ROAD DEPARTMENT

ADDENDUM NO. 1

HUNNELL RD: LOCO RD TO TUMALO RD

The Bidding Documents for the HUNNELL RD: LOCO RD TO TUMALO RD project are amended as follows:

SHEET NO.
CX05
JOB NO.
DCO-01

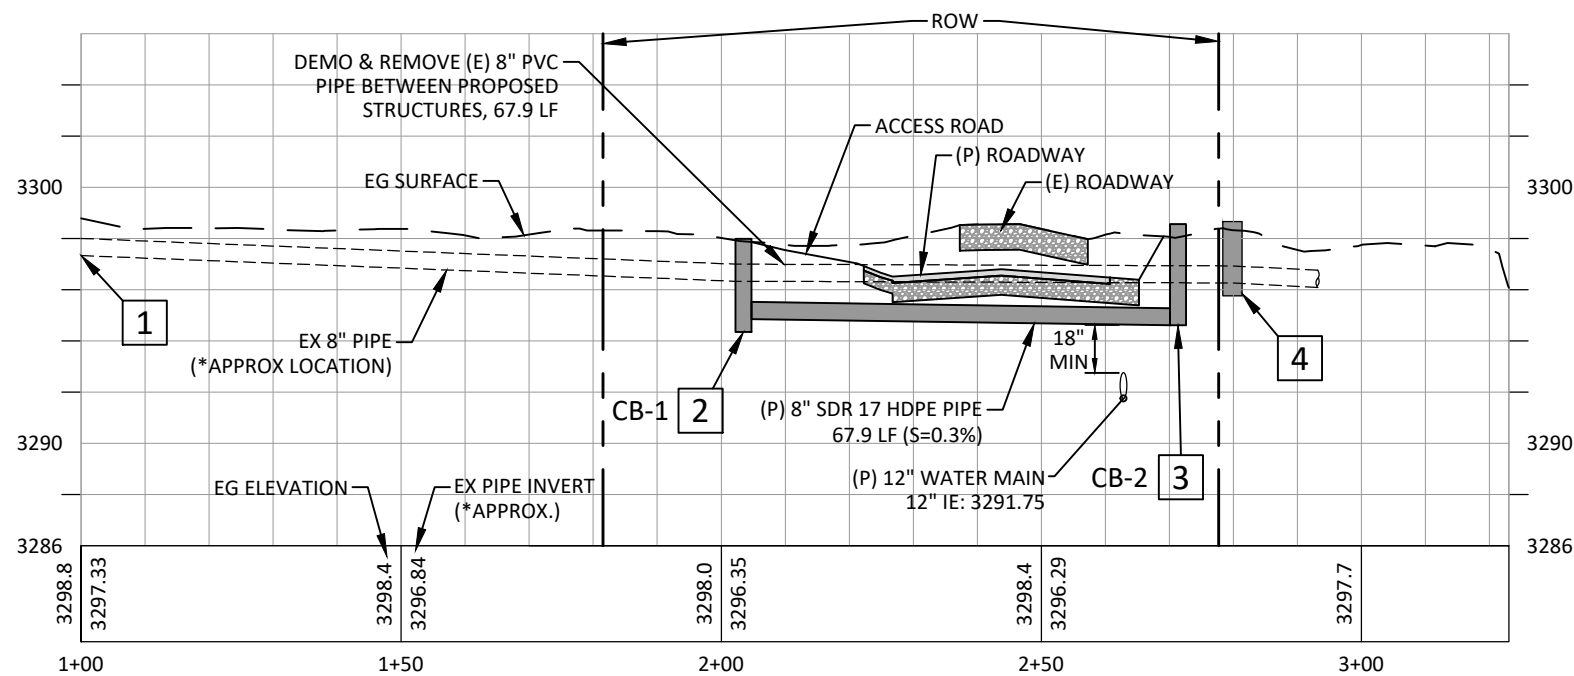
Replace sheets CX05 and CX06 in the Bidding Plans with the following sheets, which are attached to this Addendum:

2022.11.14	1	REVISE CB, ADD REFERENCE TO ODOT STD DWGS RD364, RD365, & RD376	DESIGNED:	HHPR TEAM
			DRAWN:	MD
			CHECKED:	NS
DATE	NO.	DESCRIPTION	DATE:	10.28.2022
R E V I S I O N S

- EXISTING IRRIGATION SERVICE CONNECTION (APPROX LOCATION)
STA 1+00.00, 0.0' (PIPE) = STA 275+38.52, 127.1'L (HUNNELL RD)
EX 8" IE = *3297.33±
- CATCH BASIN CB-1
STA 2+03.46, 0.0' (PIPE) = STA 274+90.16, 35.6'L (HUNNELL RD)
CONSTRUCT G-2 CATCH BASIN WITH TRAFFIC RATED GRATE PER
ODOT STD DWG RD364 & RD365; CUT & CONNECT TO EXISTING
8" IRRIGATION SERVICE PIPE (WEST INVERT).
RIM = 3298.05
EX 8" IE-IN (W) = *3296.33±
8" IE-OUT (E) = 3294.85
6" SUMP = 3294.35
CONSTRUCT 67.9 LF 8" SDR 17 HDPE PIPE
@ S = -0.30% TO CB-2. SEE NOTE 3.

- CATCH BASIN CB-2
STA 2+71.36, 0.0' (PIPE) = STA 274+58.43, 24.4'R (HUNNELL RD)
CONSTRUCT G-2 CATCH BASIN WITH SIPHON BOX COVER PER
ODOT STD DWG RD364 & RD376; CUT & CONNECT TO
EXISTING 12" IRRIGATION SERVICE PIPE (EAST INVERT).
RIM = 3298.56
8" IE-IN (W) = 3294.61
EX 8" IE-OUT (E) = *3296.27±
(NO SUMP)
CONNECT TO EXISTING 8" PIPE THAT FLOWS SOUTHEAST TO
EXISTING JUNCTION BOX. SEE NOTE 4.

SHEET NO.
CX06
JOB NO.
DCO-01

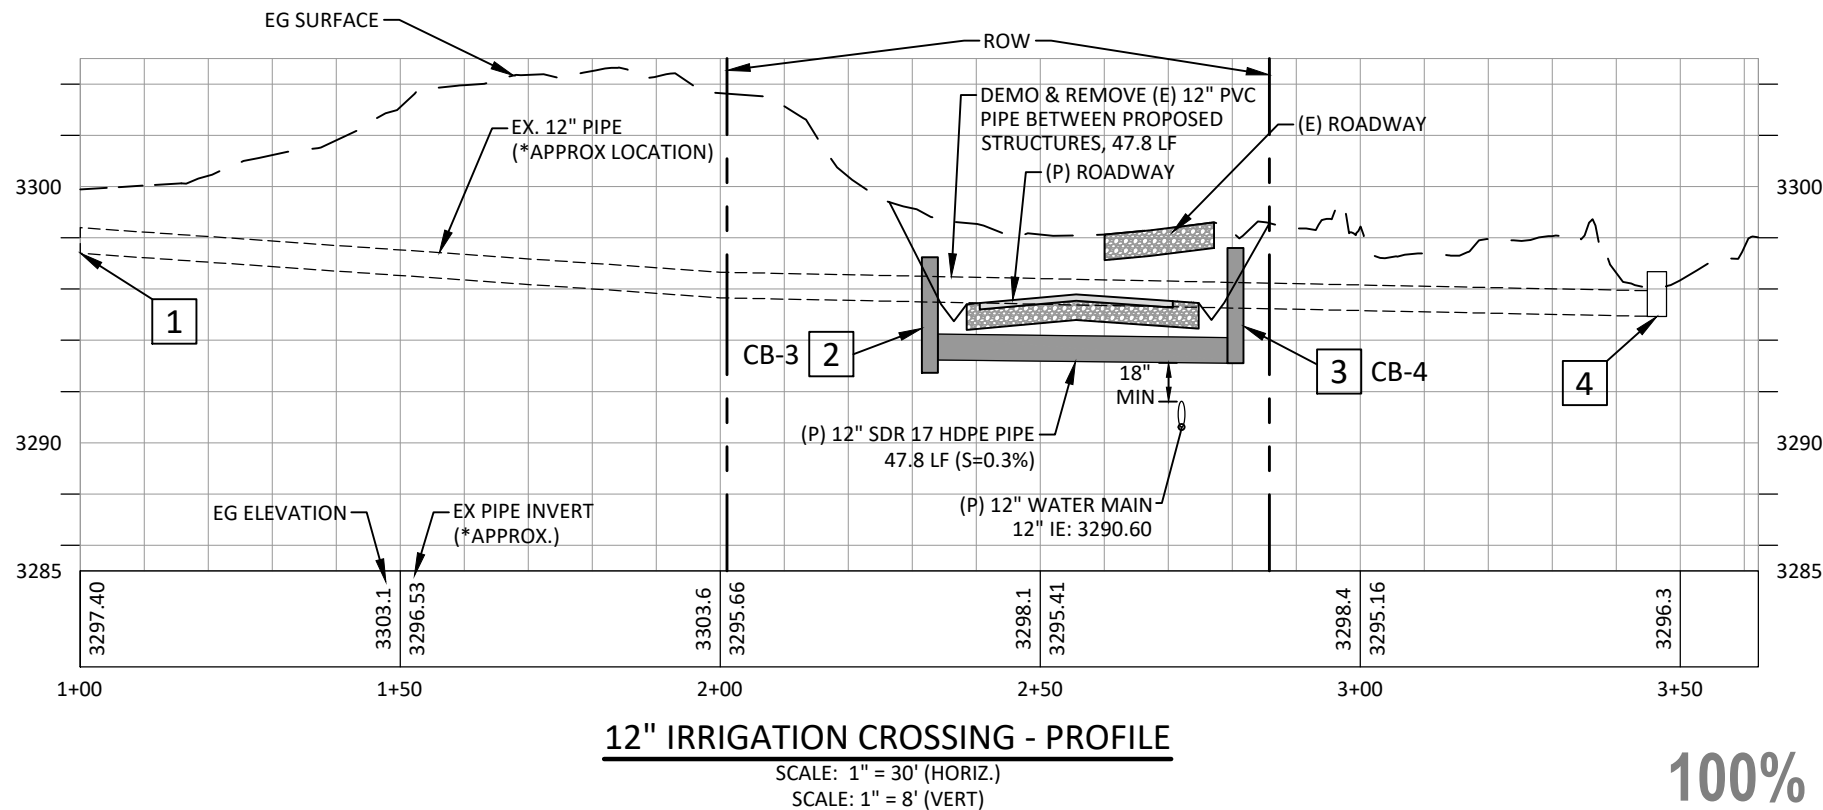
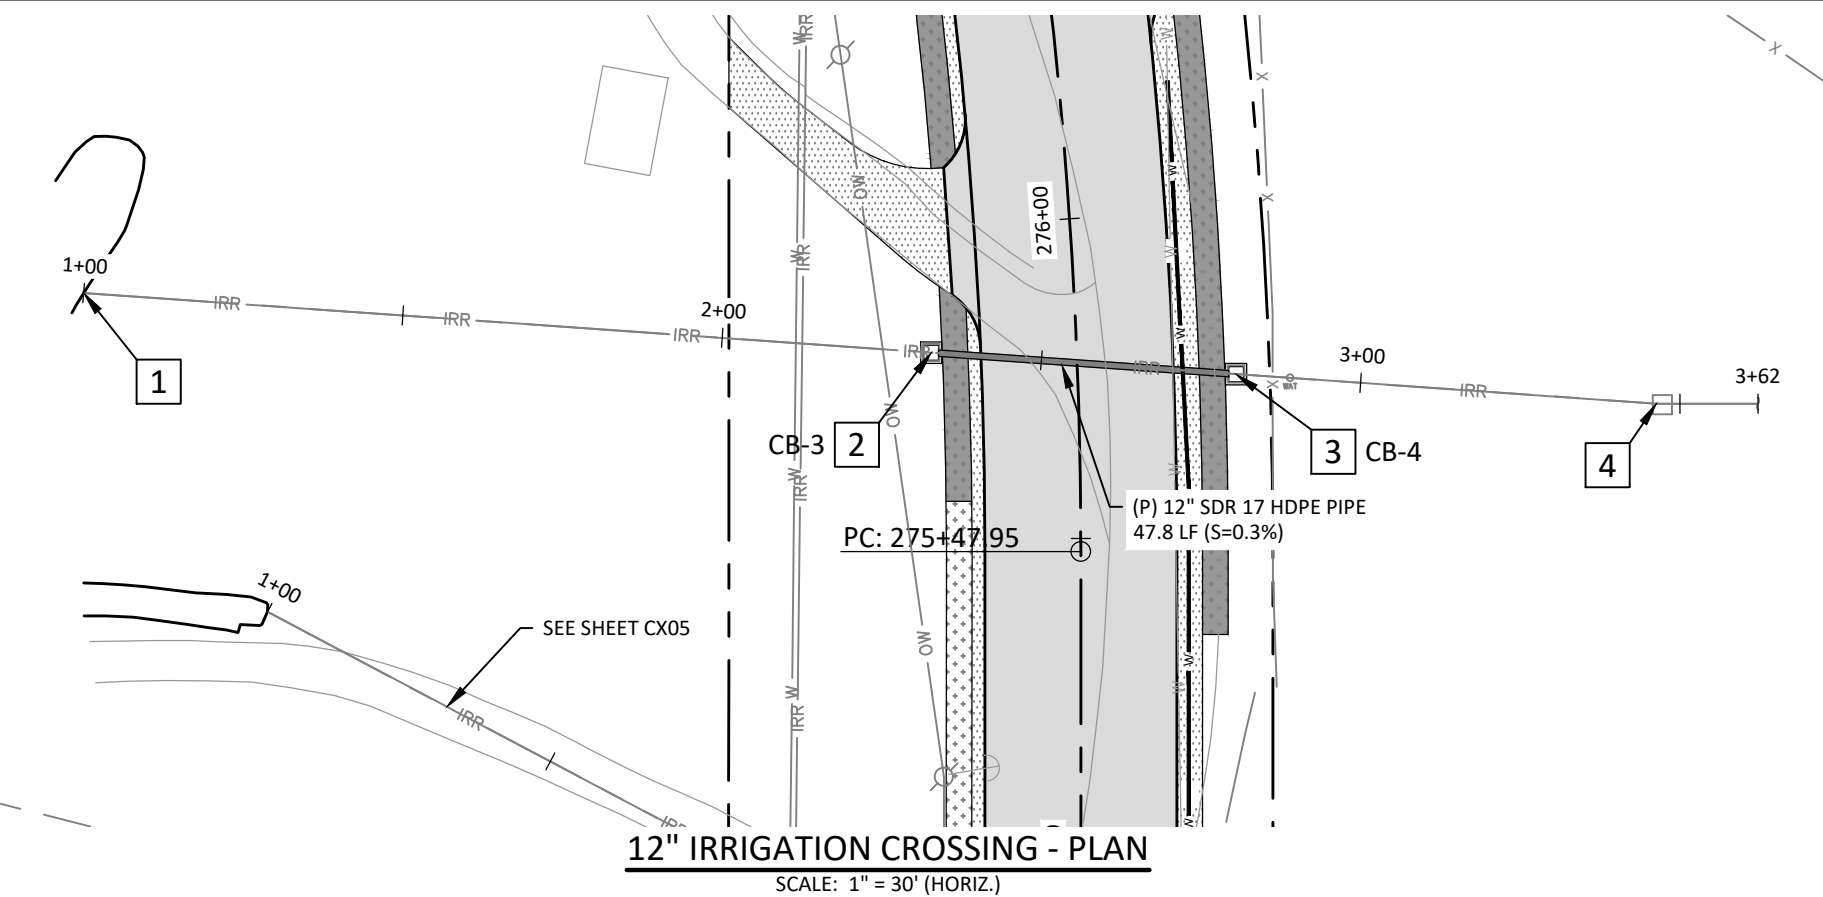
2022.11.14	Δ	REVISE CB, ADD REFERENCE TO ODOT STD DWGS RD364, RD365, & RD376	DESIGNED:	HHPR TEAM
			DRAWN:	MD
			CHECKED:	NS
DATE	NO.	DESCRIPTION	DATE:	10.28.2022
R E V I S I O N S

- EXISTING IRRIGATION SERVICE CONNECTION (APPROX LOCATION)
STA 1+00.00, 0.0' (PIPE) = STA 275+98.49, 154.5'L (HUNNELL RD)
EX 12" IE = *3297.40±
- CATCH BASIN CB-3
STA 2+32.74, 0.0' (PIPE) = STA 275+79.99, 22.7'L (HUNNELL RD)
CONSTRUCT G-2 CATCH BASIN WITH SIPHON BOX COVER PER
ODOT STD DWG RD364 & RD376; CUT & CONNECT TO EXISTING 12"
IRRIGATION SERVICE PIPE (WEST INVERT).
RIM = 3297.24
EX 12" IE-IN (W) = *3295.50±
12" IE-OUT (E) = 3293.24
6" SUMP = 3292.74
CONSTRUCT 47.8 LF 12" SDR 17 HDPE PIPE
@ S = -0.30% TO CB-4. SEE NOTE 3.

- CATCH BASIN CB-4
STA 2+80.50, 0.0' (PIPE) = STA 275+74.83, 24.7'R (HUNNELL RD)
CONSTRUCT G-2 CATCH BASIN WITH SIPHON BOX COVER PER
ODOT STD DWG RD364 & RD376; CUT & CONNECT TO
EXISTING 12" IRRIGATION SERVICE PIPE (EAST INVERT).
RIM = 3297.60
12" IE-IN (W) = 3293.10
EX 12" IE-OUT (E) = *3295.25±
(NO SUMP)
CONNECT TO EXISTING 12" PIPE THAT FLOWS EAST TO
EXISTING JUNCTION BOX. SEE NOTE 4.
